# GTS1, Hull

## Type 3 Fire Risk Assessment

Prepared for:	Rebecca Franks, Building Safety Manager
Prepared by:	John Askew, Fire Risk Assessor, Holistic Fire Safety
Date Submitted:	26/11/2025
Document Reference:	HFS.HCC.GTS1.FRA.3.0

Photo 14

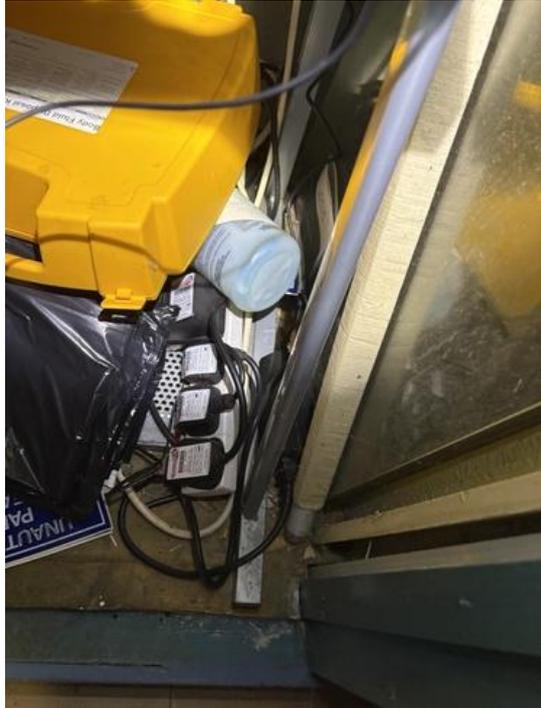
Electrical extension leads were in use in the caretaker's office. Care must be taken not to overload the maximum permitted rating of extension leads. Consideration should be given to removing extension leads and provide additional sockets to supply the equipment in use.

Remove extension leads and provide additional sockets to supply equipment which is in use.

Photo 55

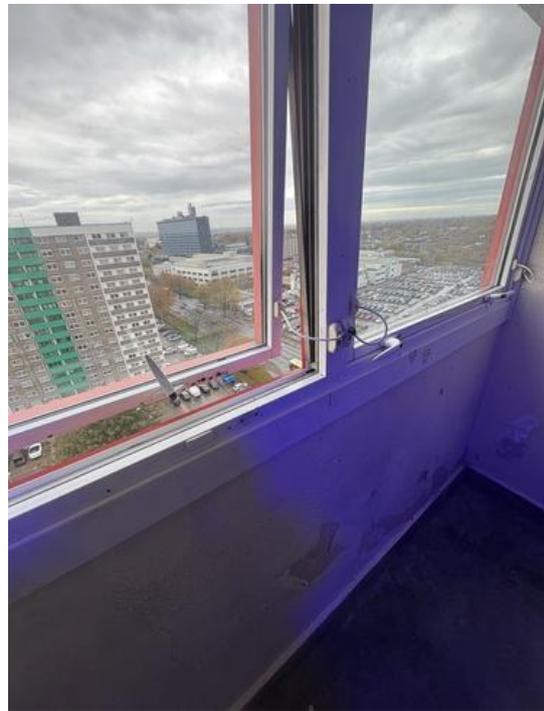
There is no ventilation to corridors which serve flats. Ventilation is provided in stairways by means of manual openable windows with restricted openings.

Current guidance states that vents in lobbies or corridors adjoining stairways should be operated automatically; however, the installation of Automatic Opening Vent (AOVs) is not considered reasonably practicable. In addition, although current openings do not provide a minimum free area of 1.5 metres squared (m<sup>2</sup>), current provisions are considered adequate given other mitigation measures in place.

Protected stairways also need means to ventilate any smoke that may enter the stairway during evacuation or fire fighting and allow a route for air to reach ventilated lobbies. A vent of at least 1m<sup>2</sup> needs to be provided at the head of the stairway for this. Current guidance states that in blocks of flats, it is recommended that the vent is operated automatically via an AOV.

HCC should review smoke control arrangements within the stairway with a view of providing AOV.

Photo 76

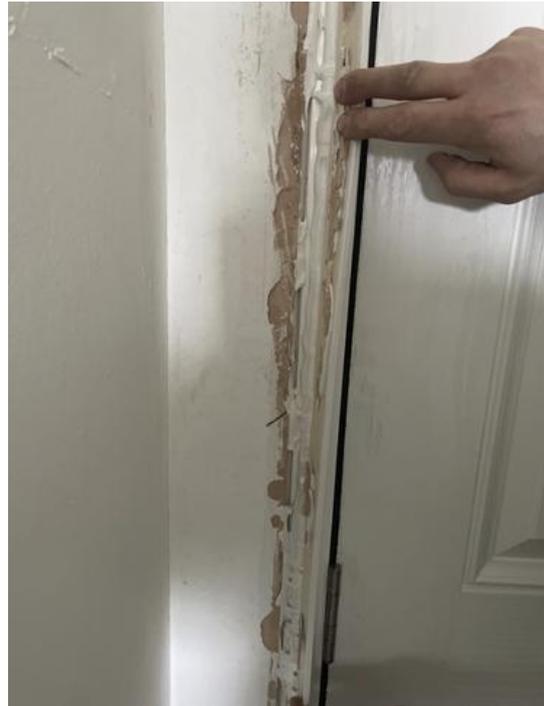
It was noted that flat 446 self-closing device has been repositioned to the opposite side of the door leaf. This has effectively compromised the integrity of the door. The door leaf should be repaired or replaced.

Repair or replace flat 446 door leaf.
